Access Compliance Report

Public Rights-of-Way

(Pedestrian Signals)

Intersection ID: N/A	Main Street:	Cross Street: N/A	Location: N/A
ADA ID: FD953F371D92	Signal Type: One Push Button-APS	Overall Compliance: No	Severity Score: BTN 1: N/A BTN 2: N/A No BTN: N/A
Codes/Mitigation Info/Possible Solution		Field Measurements/Component Compliance

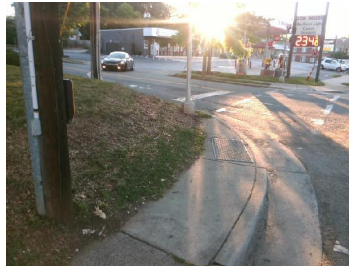
Surveyor Notes: TEXT HT 3/8

PROW/ADA: R410.6, R209.1, TMUTCD 4e.08,
R404.7.3, MUTCD 4e.10

Possible Solutions: Remove & Replace
Replace APS Button With New APS Button.
